# Access Compliance Report

## Public Rights-of-Way

### (Curb Ramps)

Intersection ID: N/A	Main Street: E MARTIN LUTHER KING JR BV	Cross Street: S COLLEGE ST	Location: E
ADA ID: 619A921AC04E	Ramp Type: PerpDiag	Initial Pass/Fail: Fail	Overall Compliance: No
Severity Score: 50			
Codes/Mitigation Info/Possible Solution		Field Measurements/Component Compliance

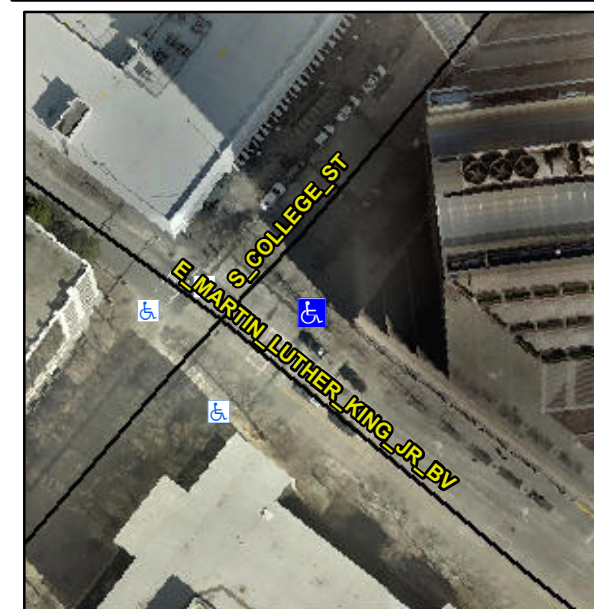
Compliance	Description	Data	Compliance	Description	Data
N/A	Ramp Length (in)	72.0	No	Ramp Slope (%)	12.9
Yes	Ramp Width (in)	72.0	No	Ramp XSlope (%)	7.0
N/A	Flare Type LT	N/A	N/A	Flare Type RT	N/A
N/A	Flare Slope LT (%)	N/A	N/A	Flare Slope RT (%)	N/A
N/A	Flare Traversable LT?	No	N/A	Flare Traversable RT?	No
N/A	Landing Length (in)	N/A	N/A	DWS Provided?	N/A
N/A	Landing Width (in)	N/A	N/A	DWS Contrast?	N/A
N/A	Landing Slope (%)	N/A	N/A	DWS Length (in)	N/A
N/A	Landing X Slope (%)	N/A	N/A	DWS Full Width?	N/A
N/A	Landing Curb? (Y/N)	N/A	N/A	DWS Offset (in)	N/A
N/A	Shared Landing?	N/A			
N/A	Gutter Ponding?	N/A	N/A	Gutter Slope (%)	N/A
N/A	Gutter Lip Ht (in)	N/A	N/A	Gutter X Slope (%)	N/A
N/A	Painted X Walk1?	No	N/A	Painted X Walk2?	No
	X Walk 1 Direction	To NW		X Walk 2 Direction	To SW
N/A	X Walk 1 Width (in)	N/A	N/A	X Walk 2 Width (in)	N/A
	X Walk 1 Slope (%)	6.4		X Walk 2 Slope (%)	2.4
	X Walk 1 X Slope (%)	6.2		X Walk 2 X Slope (%)	8.7

N/A	Ramp inside XWalk1?	N/A	N/A	Ramp inside XWalk2?	N/A
	Road Slope (%)	6.8	N/A	Clear Space?	N/A
	Road X Slope (%)	5.1	N/A	Clear Space to XWalk (in)	N/A
N/A	Any Obstructions?	N/A	N/A	Storm Grate/Utility Hazard?	N/A
	Obstruction Type			Storm Grate/Utility Type	
		N/A			N/A
		Yes		Surface Condition? (G/P)	Good

**Remove & Replace Curb Ramp With Two New Directional Ramps or Equivalent.**
